## LETTER DECISION

File OF-Fac-IPL-H141-2016-01 01

**Hydro-Québec TransÉnergie (HQT)  
Permit Application for the Quebec-New Hampshire Interconnection  
Pursuant to section 58.11 of the *National Energy Board Act*  
Application to amend the definition of the 450 kV Interconnection  
Quebec-New England in Certificate EC-III-021  
Letter Decision**

**Figure 2 – Future Configuration**

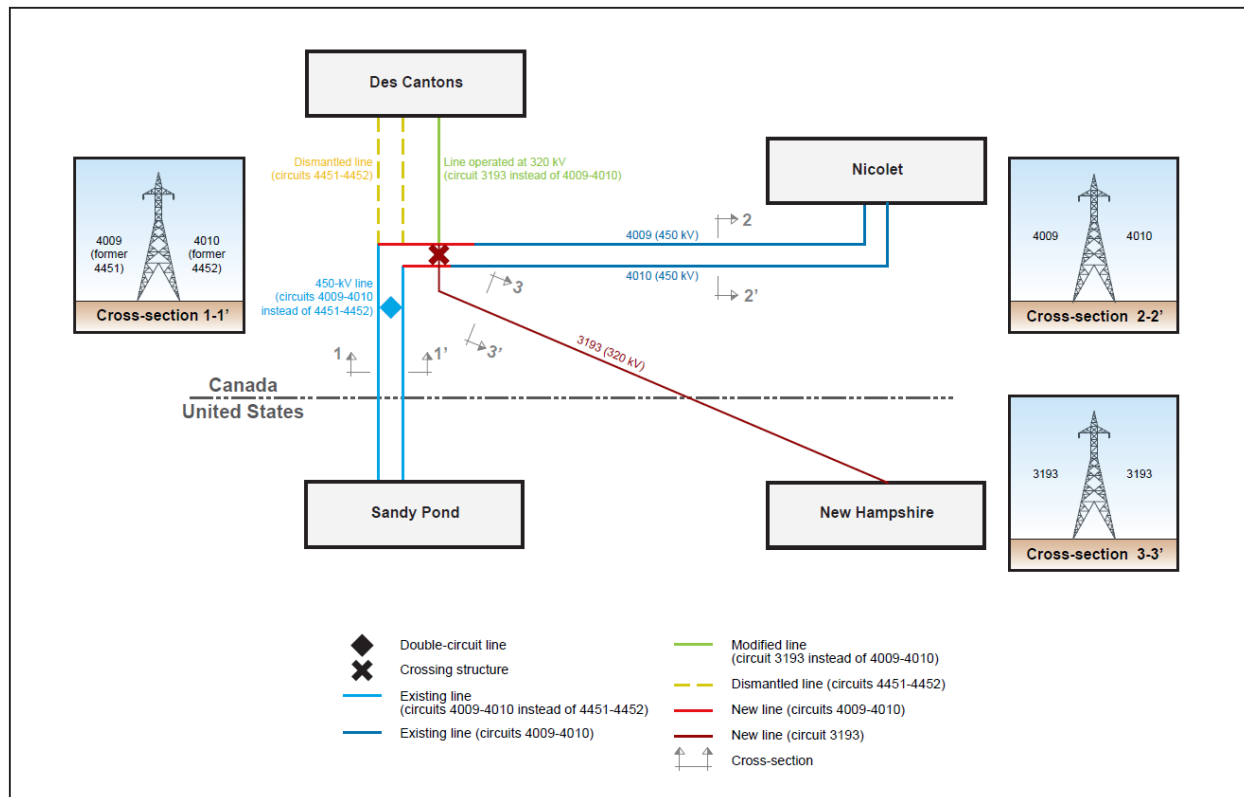
To implement the proposed 320 kV Permit Project, the existing 450 kV lines near Des Cantons Substation must be reconfigured. Figure 2 shows the proposed reconfiguration. As shown in Figure 2, the reconfiguration proposes to:

- 1) join lines 4009-4010 from Nicolet to the portion of lines 4451-4452 which go to Sandy Pond;

- 2) dismantle/salvage a section of the 4451-4452 lines coming out of Des Cantons;
- 3) downgrade the remaining section of the 4009-4010 lines coming out of Des Cantons +/- 320 kV operation and join to the new section of the Permit Project.

At the crossing structure shown in Figure 2, the proposed 320 kV line will run beneath the 450 kV line and connect to a set of rigid busbars. A steel structure will be erected above the 320 kV busbars to protect them from making electrical contact with any conductors that may fall from the line above.

The Board is of the view that the Variance Application is necessary to enable the operation of the Permit Project. It is also of the view that the overall design of the Variance Application makes use of sound engineering practice with regards to the structural design of the crossing structure, layout, line and structure numbering, equipment selection, transfer capacity and reliability.
